UNITED STATES PATENT AND TRADEMARK OFFICE

APPLICATION NO.	FILING DATE	FIRST NAMED INVENTOR	ATTORNEY DOCKET NO.	CONFIRMATION NO.
10/579,956	02/20/2007	Mark Christopher Lindley	SWIN 3486	9290

Office Action Summary

DETAILED ACTION***Claim Rejections - 35 USC § 102/103***

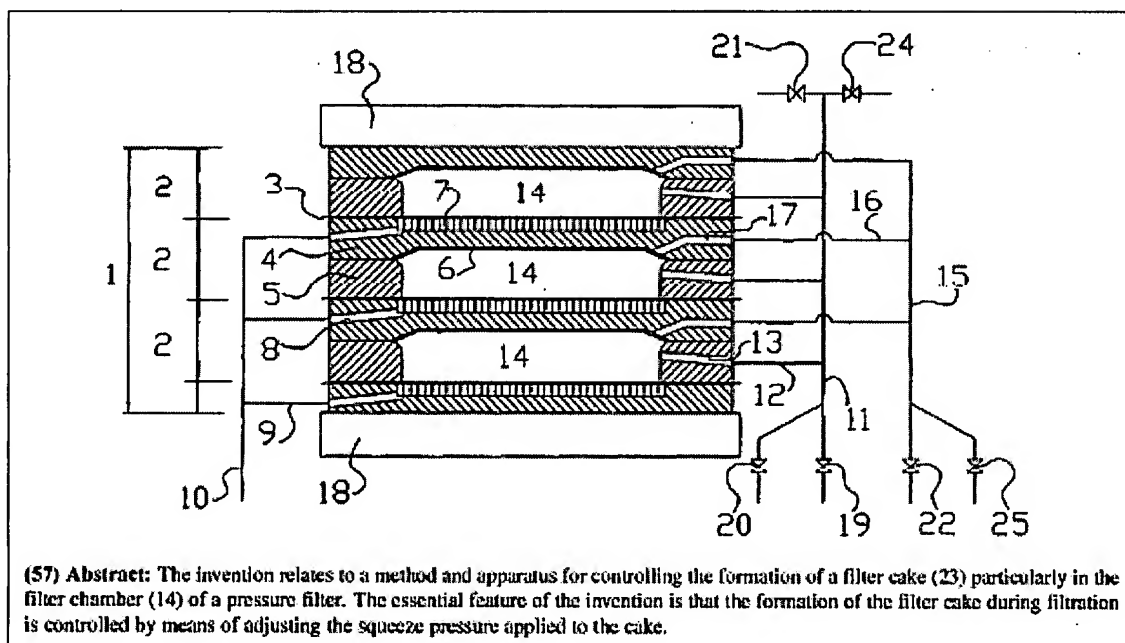
Claims 12-19 are rejected under 35 U.S.C. 102(b) as anticipated by or, in the alternative, under 35 U.S.C. 103(a) as obvious over **WO/057344 A1**.

Referring to FIG. 1, a clamped filter plate stack 1 shown therein comprises a number of separate filter plates 2, having a filter cloth 3 draped therebetween. Typically, the filter plate 2 is formed by a bottom plate 4, a frame 5 and a flexible diaphragm 6, such as a rubber sheet, attached therebetween. The top surface of bottom plate 4 is covered by a drainage screen 7 that supports filter cloth 3 and thus facilitates the drainage of the liquid fraction, called the filtrate, separated from the slurry/sludge through the filter cloth into a drainage channel 8 situated at the top surface of the bottom plate 4 and therefrom further via a drainage hose 9 into a filtrate discharge pipe 10.

It is submitted that this teaching meets the limitations of the claims.

FIG. 4

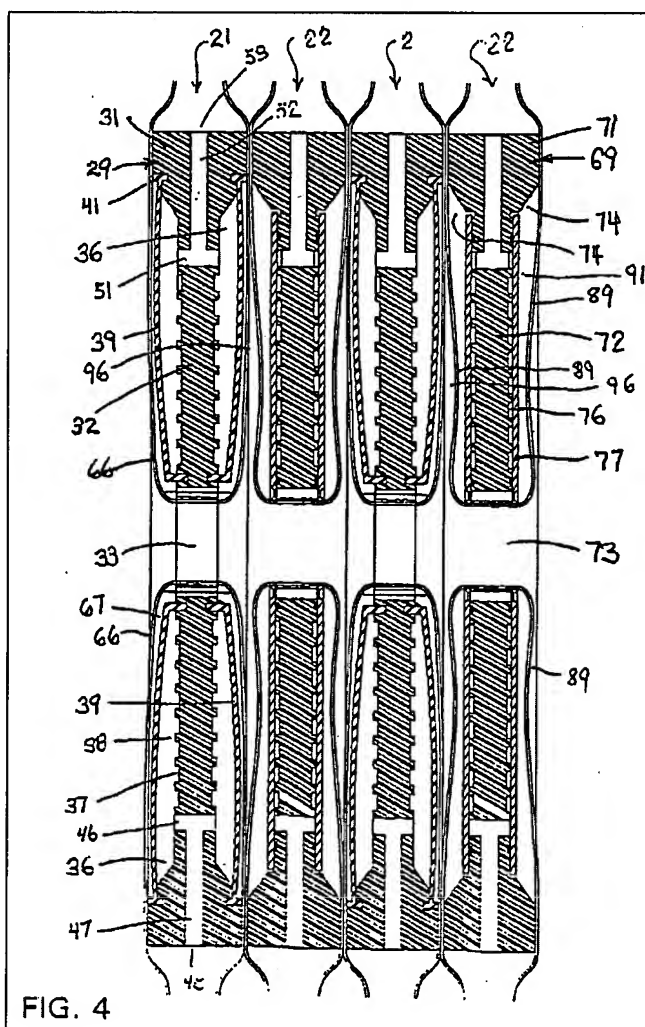
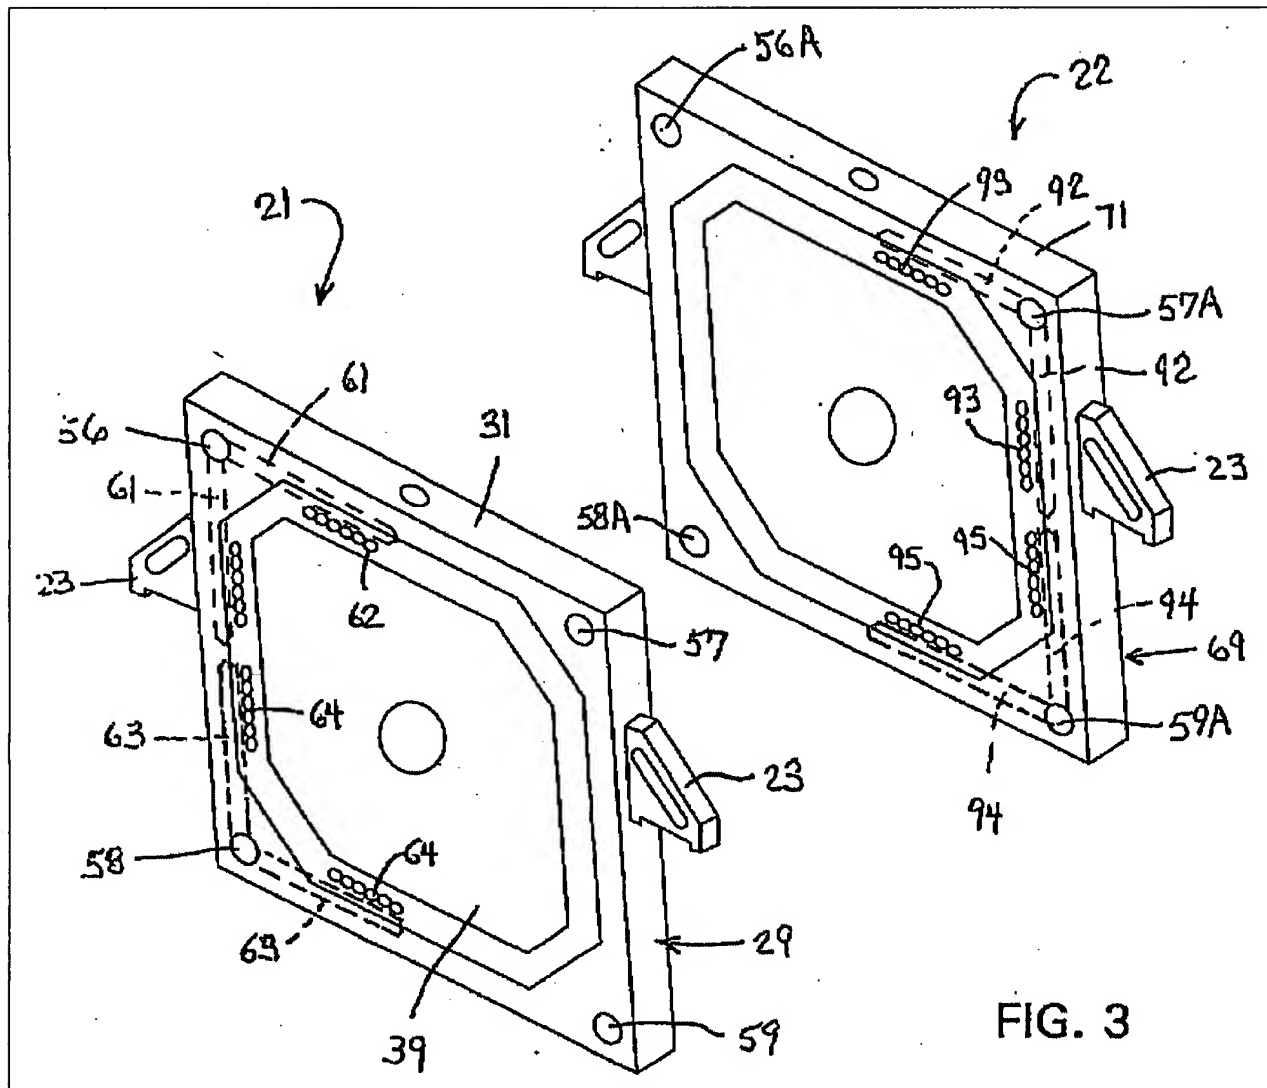
Claim 12-19 are rejected under 35 U.S.C. 102(e) as anticipated by or, in the alternative, under 35 U.S.C. 103(a) as obvious over **Hildebrandt (US 2006/0032805)**.

A filter press (11) defined by a closable stack of filter plates defined by a first plurality of membrane filter plates (21) alternately disposed with a second plurality of heating-type filter plates (22). The membrane plates (21) have chamber-defining recesses on opposite sides thereof, with each recess (36) having a flexible membrane (39) associated therewith which can be pressurized from the rearward side so as to effect squeezing of the cake in the filtration chamber. Each heating plate (22) also has chamber-defining recesses (74) on opposite sides thereof, and the main center bottom wall (76) of each recess (74) has a metal heat transfer surface (77) associated therewith, the rear side of which is in intimate contact with a chamber or passage (79) which receives therein a high-temperature heat transfer fluid.
